HVAC PLAN

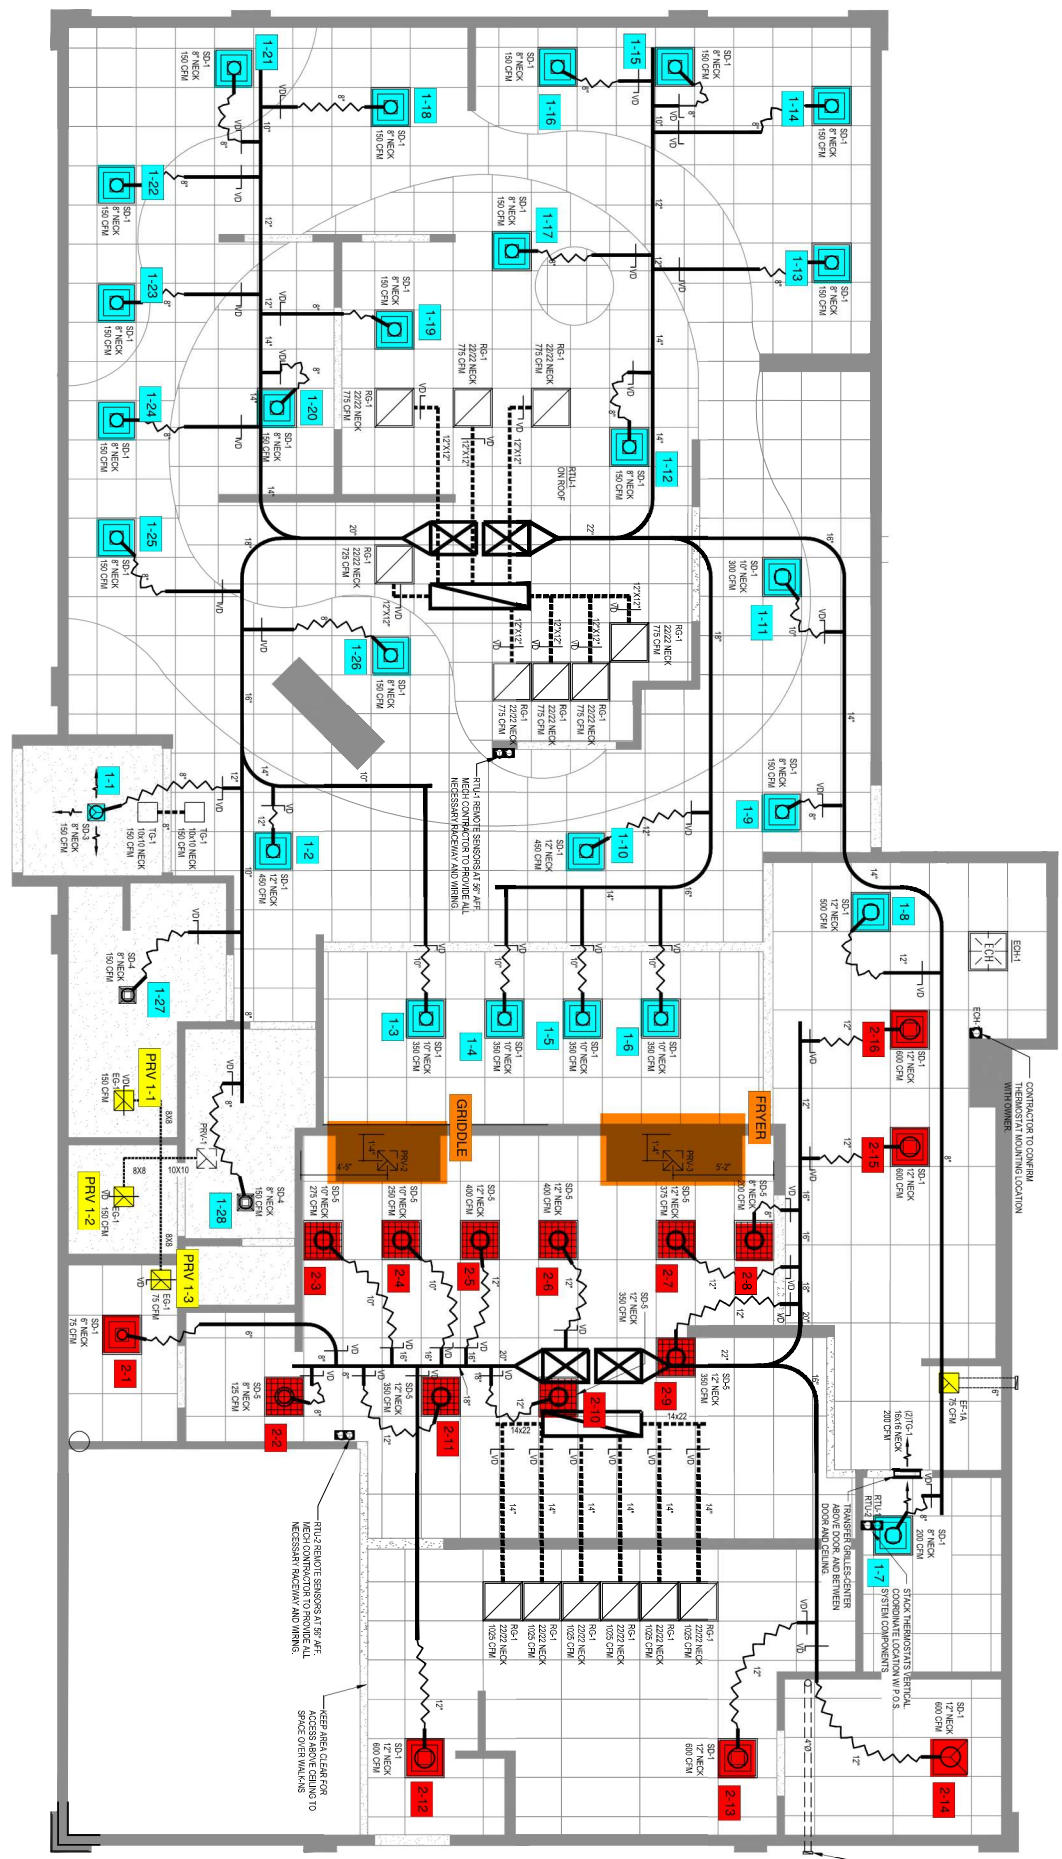
CONTRACTOR TO CORRECT THERMISTAT MOUNTING LOCATION WITH OWNER

RTU-1 REMOVE SENSORS AT AFF. MESSAGING ROOM AND WALKERS

RTU-1 REMOVE SENSORS AT AFF. MESSAGING ROOM AND WALKERS

IF SPRING EQUALIZER FOUND, WALKER, MATCH WALL CAP TO MATCH EXTERIOR
